Appl. No. 10/604,569
Amdt. Dated 4/26/2005
Reply to Office action of 04/06/2005

REMARKS/ARGUMENTS

Amendments to the Drawings

Figure 1

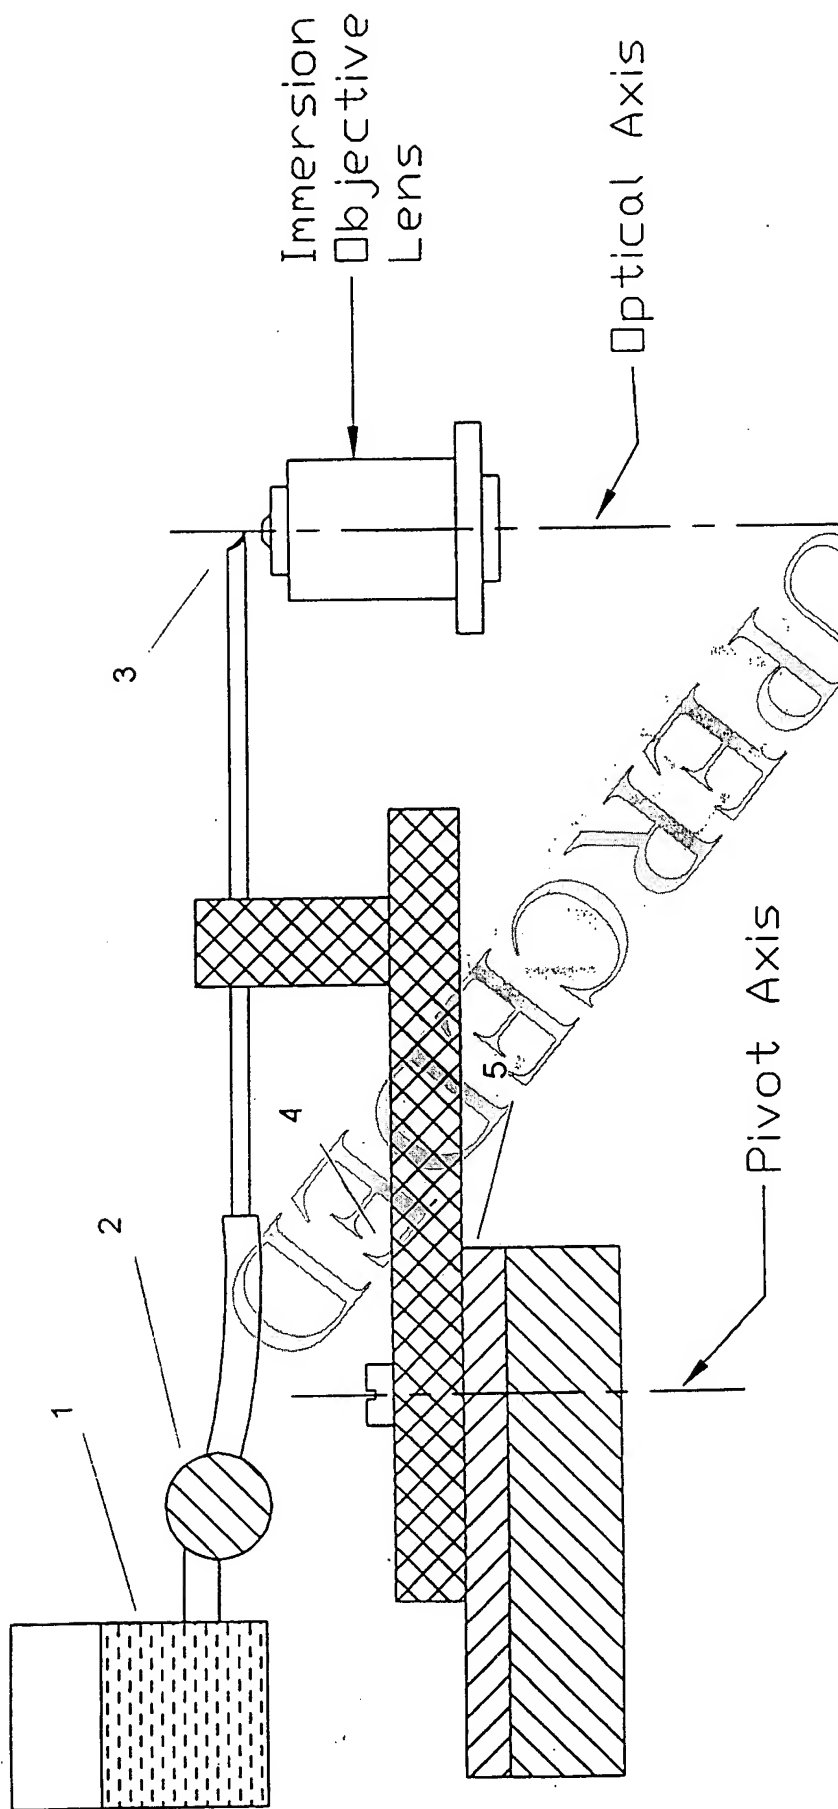
This appendix contains the original Figure 1. The replacement drawing for this figure is contained in the "Amendments to Drawings" section in the body of this submission.

The following figure is a replacement for Figure 1 of the application. This figure has been revised to include the coaxial vacuum channel.
